SERVICE BULLETIN TA-SB-D-01-2017

Preventative inspection of the exhaust system on the gyrocopter G 4-2 type Ti and TiS.

Fig.1

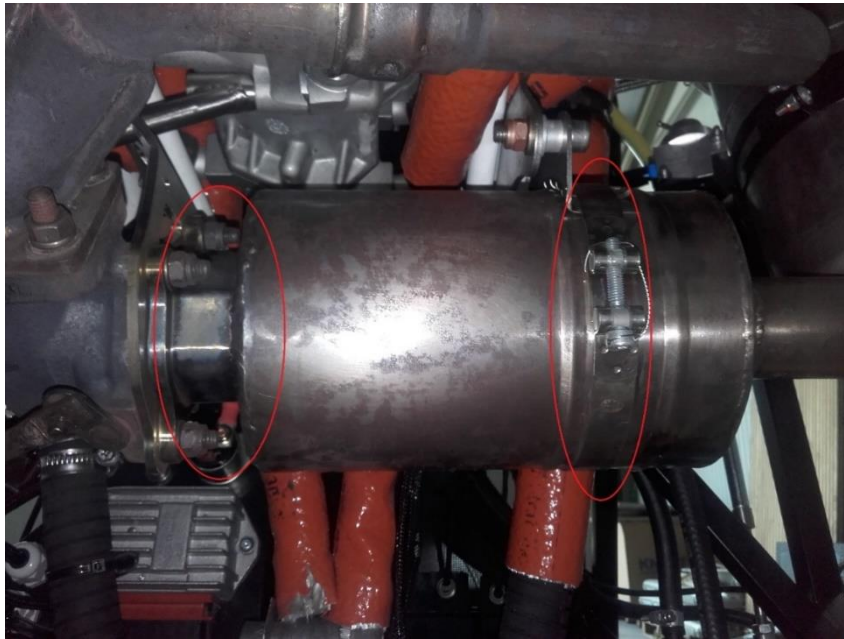
- a) Before first flight it is needed to inspect exhaust system, to see if there are any cracks and/or if the clamp is broken. (See highlighted red circles in Fig 1).
- b) Width of the clamp ($\varnothing 121\text{mm}$) must be 28 mm, if it's 15mm wide it should be changed for clamp with the width of 28mm. The clamp must be fastened by the torque 15Nm. (Fig. 2).
- c) Any cracks on the exhaust, it is needed to be dismantled and sent it to the Trixy Aviation d.o.o.
